Notice of requirement: Kumeū Secondary New Site - D002497.01
 Ministry of Education Response to Further Information Request

Response to Auckland Council and Auckland Transport Requests for Further Information

The purpose of this memo is to respond to transport matters raised by Auckland Council and Auckland Transport, in regard to the Notice of Requirement for a proposed Secondary school at 54 & 60 Station Road and 43 Trigg Road in Kumeu. The matters for discussion provided by Auckland Council are set out in blue italics, followed by Abley's response.

Figure 2.1 Bus Services in the indicative school catchment (Source: AT GIS Portal)

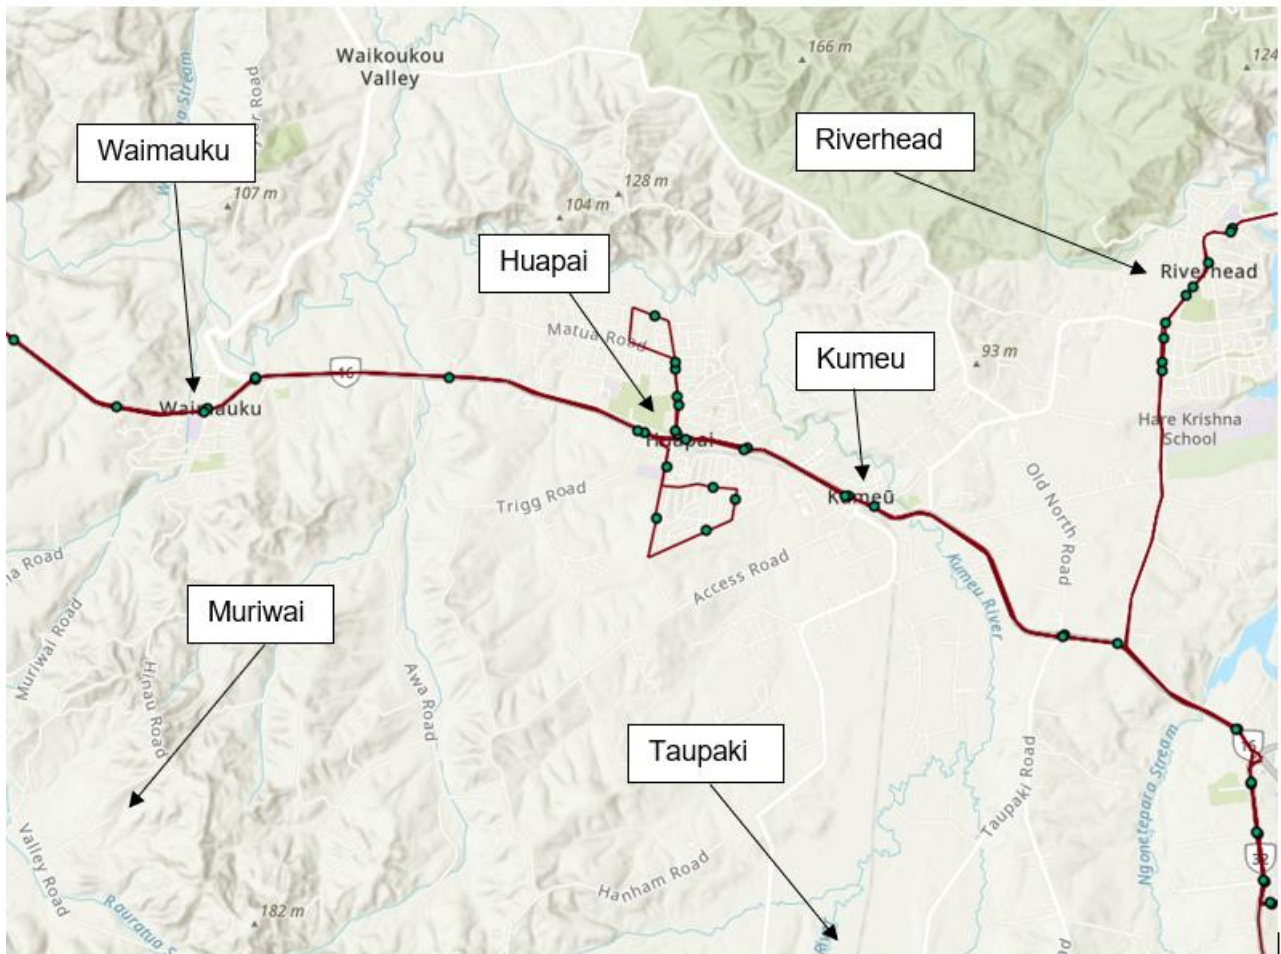
A1. The ITA (sections 3.2 and 7) suggest that AT should be requested to provide additional Route 123 buses at school start and finish times. The 123 bus route is an hourly service. AT notes that this route would only be useful for school pupils living at the west end of Kumeū, which is a small residential catchment. The number of pupils likely to use the service may not warrant additional services during off-peak times. If students use the 122 or 125 bus routes, AT has concerns about student safety. There is no pedestrian crossing across SH16 for students to safely access eastbound bus services

Figure 2.1 shows the current bus routes in relation to the catchment townships. The majority of the townships (Waimauku, Huapai, Kumeu and Riverhead) have a bus service.

Figure 2.2 Vehicle route from Taupaki to school site

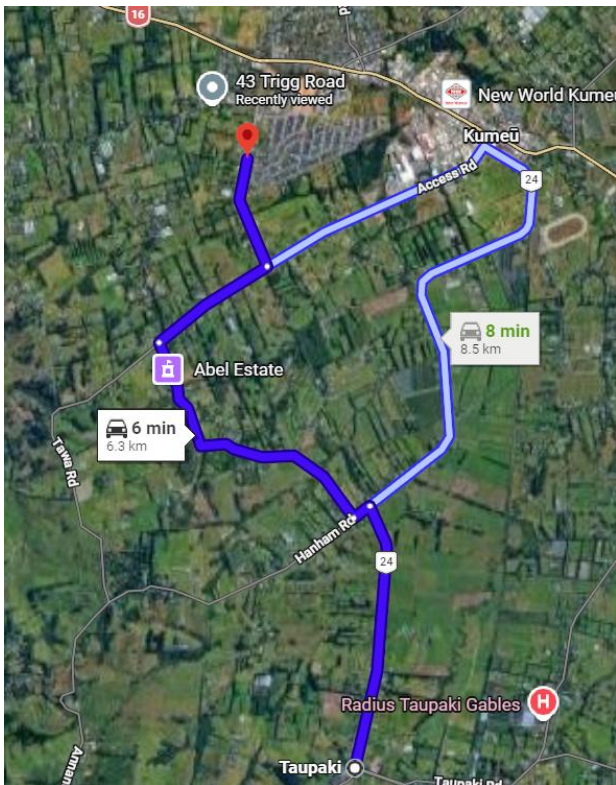
8. Please provide data that supports the distribution of school related traffic presented in Figure 13 of the Integrated Transportation Assessment (ITA).

The two communities that are not serviced by public transport are Muriwai and Taupaki. Figure 2.2 and Figure 2.3 illustrate the optimal driving routes from Muriwai and Taupaki to the school, indicating that traffic from these towns is unlikely to use the SH16 intersections.

Figure 2.17 Bus route 123 doing a loop around Huapai SHA Triangle

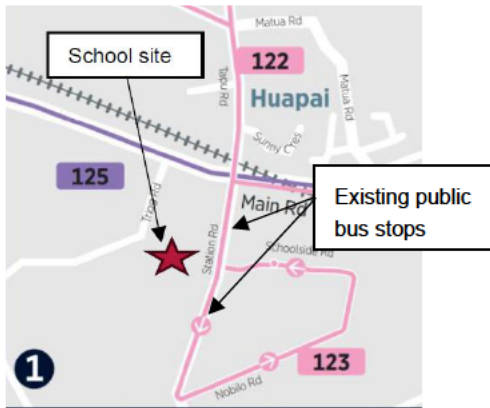
18. Please provide details of what measures will be provided to enable buses to serve the proposed school given there are no bus stops on the western side of Station Road for northbound buses.

As seen in Figure 2.17, Bus Route 123 does a loop from Station Road – Nobilo Road – Schoolside Road. Students catching the bus in the afternoon can use the bus stops on the eastern side of Station Road before the bus loops around the residential streets. There are two bus stops for use by school students, one approximately 130m to the north and a second bus stop 110m to the south.

A1.2 SIDRA model layout & Phasing Summary for SH16 / Station Road Intersection

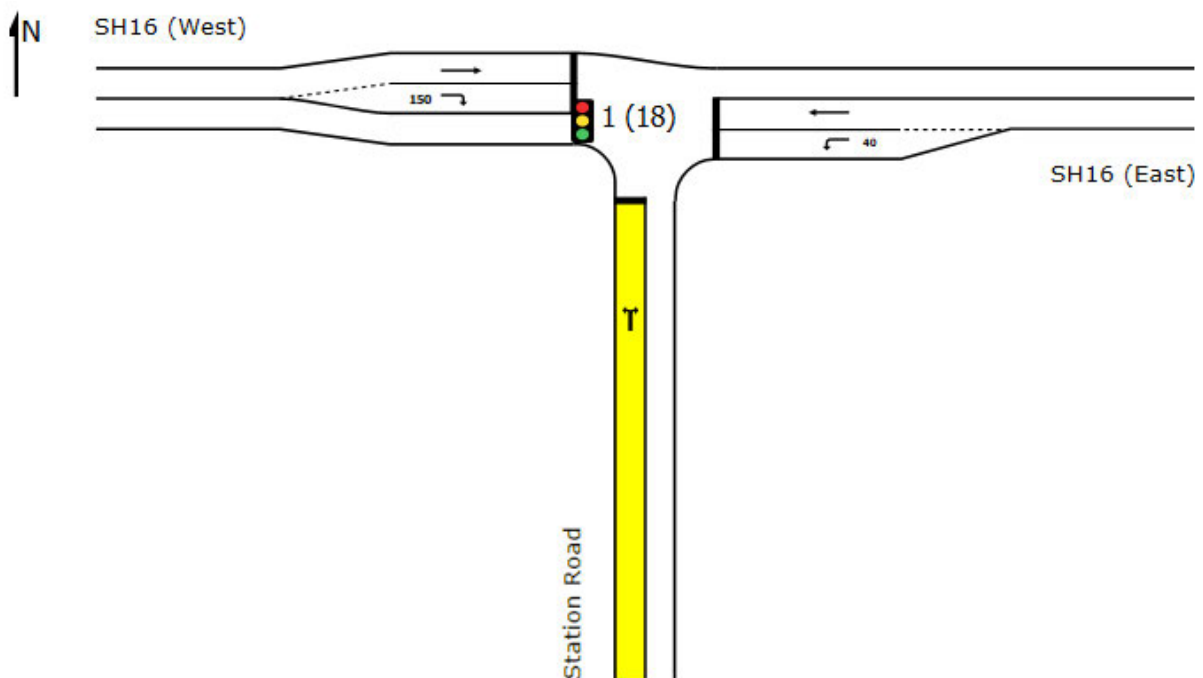
5. Please provide SIDRA model layout drawings and modelled traffic signal phasing (where appropriate) for the three intersections modelled.
